PRELIMINARY FINDINGS FROM REVIEW OF USGS STUDY IN CUYAMA VALLEY BASIN

PRESENTED TO: CUYAMA BASIN GSA

7 FEBRUARY 2018

Preliminary Findings from Review
of the USGS Study of the
Cuyama Valley Groundwater Basin

THE USGS STUDY AND MODEL ONLY CONSIDERS PART OF THE BASIN

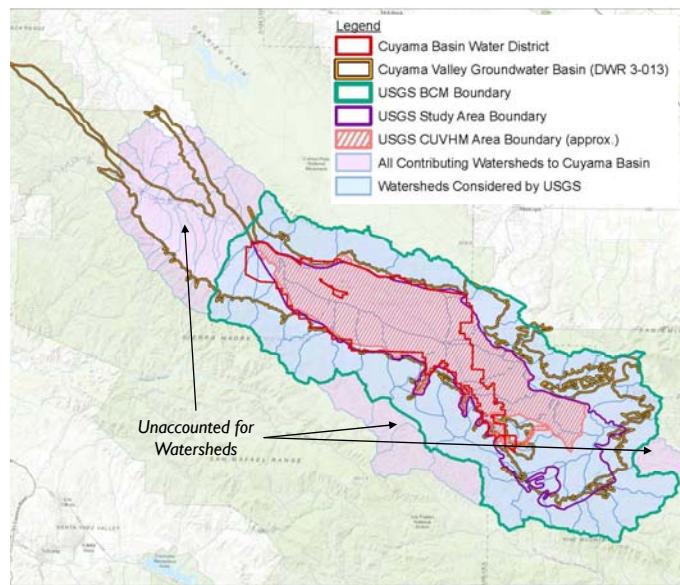
- USGS Study (and associate HCM) only considers 61% of the Basin area
- The USGS numerical model (and associated water budget) only covers 44% of the Basin area
- Only 41 out of 58 contributing watersheds are accounted for

NOT ALL SUBREGIONS ARE FAULT BOUNDED

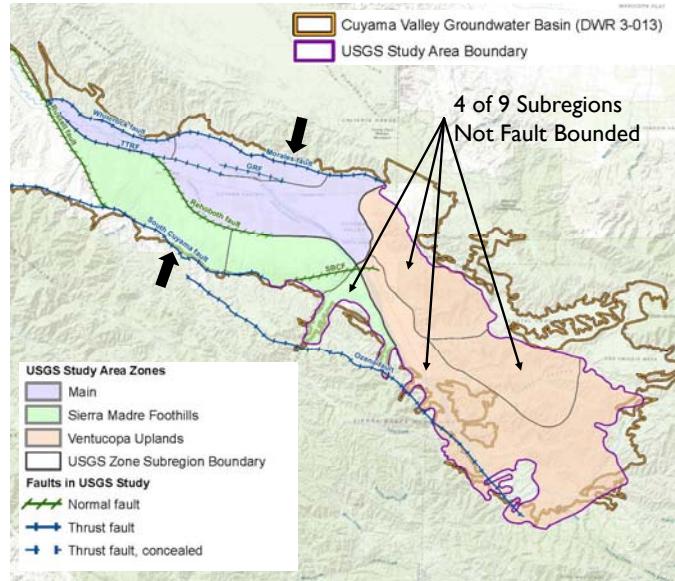
- USGS Study states that hydrologic subregions “are fault bounded” (Hanson et al., 2014), but that is actually only the case for some

FAULTS PROPERTIES ARE NOT APPLIED CONSISTENTLY

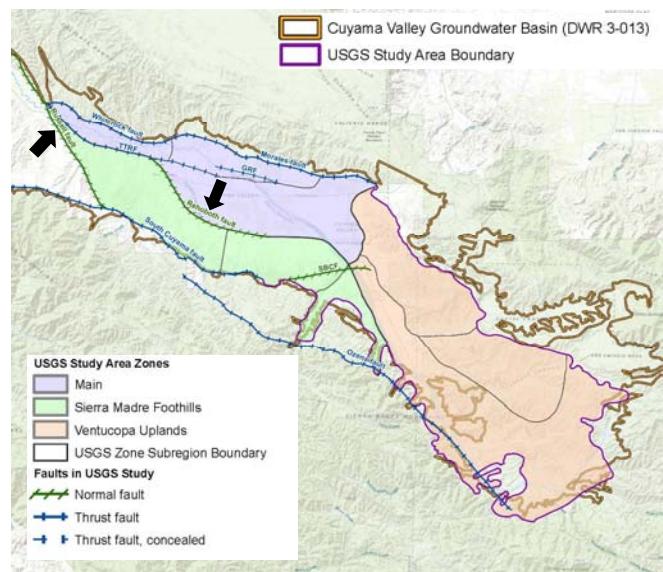
- Russell fault and Rehoboth fault have been modeled as barriers to flow in the USGS model (Hanson et al., 2014).
- The HCM states the Russell fault and Rehoboth (Farms) fault “did **not** appear to be acting as a contributing barrier to groundwater flow” (Everett et al., 2013)
- DWR denied the 2016 Basin Boundary Modification Request because “it was not demonstrated that the Russell Fault is a hydrogeologic barrier to groundwater flow”*

GROUNDWATER GRADIENTS ARE NOT ADEQUATELY CHARACTERIZED

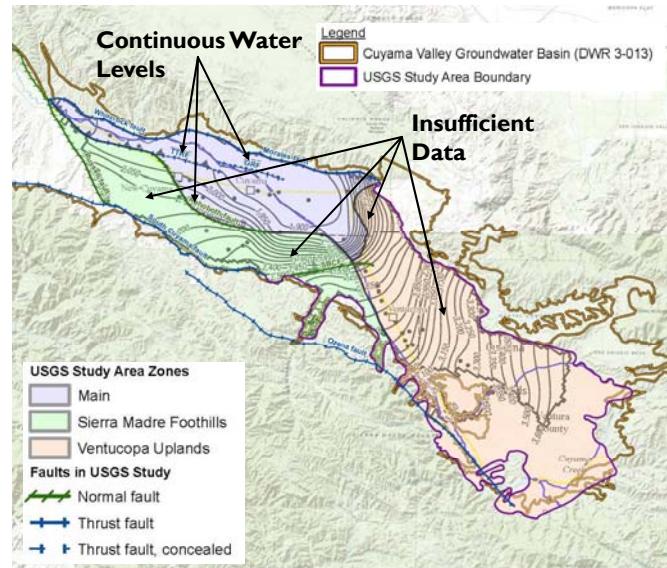
- Data gaps exist in characterization of groundwater-flow conditions in many areas of the Cuyama Basin:
 - Northern Ventucopa Uplands
 - Sierra Madre Foothills
- Fault parameterization (as barriers to flow) is often not supported by data - continuous groundwater level conditions exist across:
 - Rehoboth fault
 - Turkey Trap fault
 - Graveyard Ridge fault

WATER QUALITY DIFFERENCES BETWEEN USGS ZONES VARY, BUT NOT DEFINITIVELY

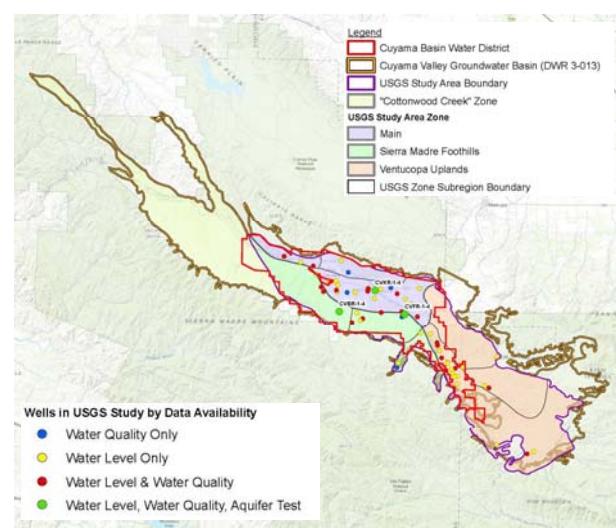
- The USGS study relied on “different water quality characteristics” (Hanson et al., 2014) to delineate between zones and hydraulic subregions.
- Water quality samples collected from 39 wells and analyzed for up to 53 constituents
- However, examination of these water quality and stable isotope data reveals that these differences are unclear

PIPER DIAGRAMS DO NOT INDICATE DISTINCT WATER TYPES

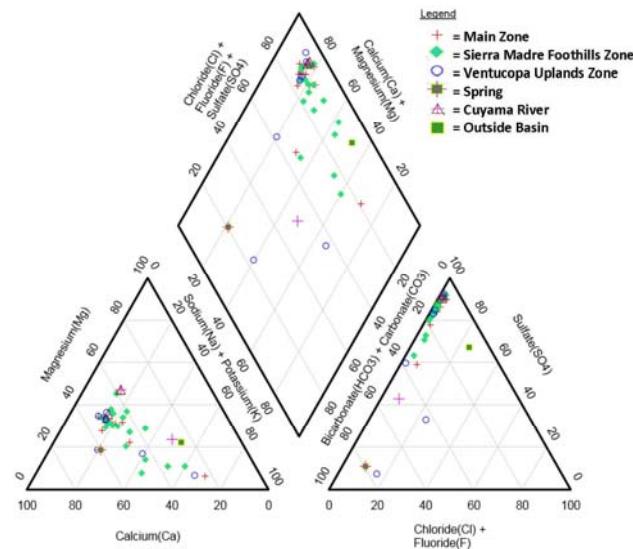
- Significant variability existed from sample to sample
- Most water characterized as “calcium-magnesium sulfate waters”
- Plotting of major cation data on Piper diagrams does not indicate distinct water types between the multiple zones

OXYGEN AND HYDROGEN ISOTOPES RATIOS SUGGEST COMMON RECHARGE SOURCES

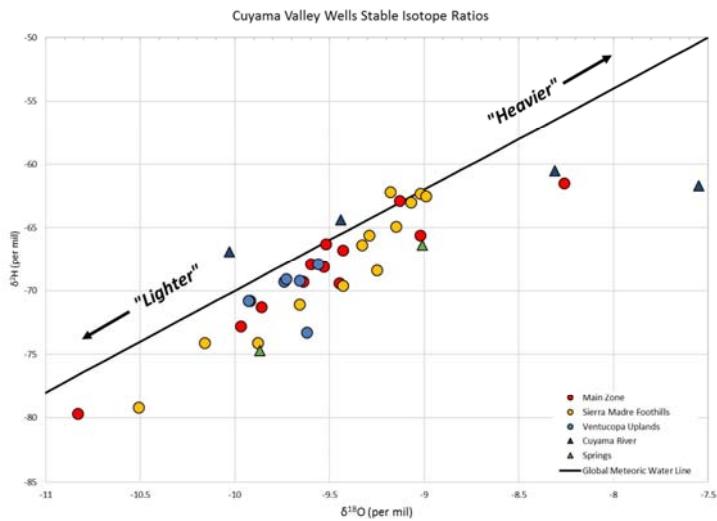
- Recharge from Cuyama River expected to have “lighter” isotope ratio
- Recharge from direct precipitation expected to have “heavier” isotope ratio
- Plotting of stable isotopes of oxygen and hydrogen by zone shows very little distinction in isotope ratios between zones

DISCREPANCIES EXIST BETWEEN USGS STUDY AND ARCHIVED MODELS

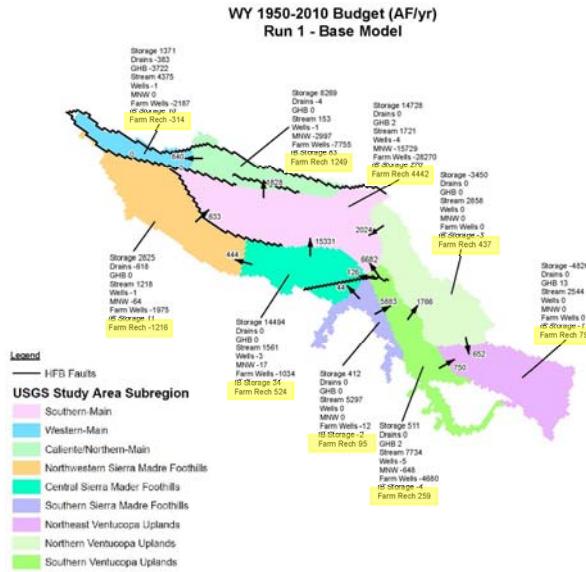
- The EKI Team ran the numerical model (obtained from the USGS Model Archive) and compared results to the corresponding output from the USGS Model Archive
- Model-calculated and archived water levels agreed, but discrepancies exist between the water budgets, with most of the discrepancy attributable to “Farm Recharge”
- These discrepancies indicate that the numerical model results reported in the USGS Study are not reproducible
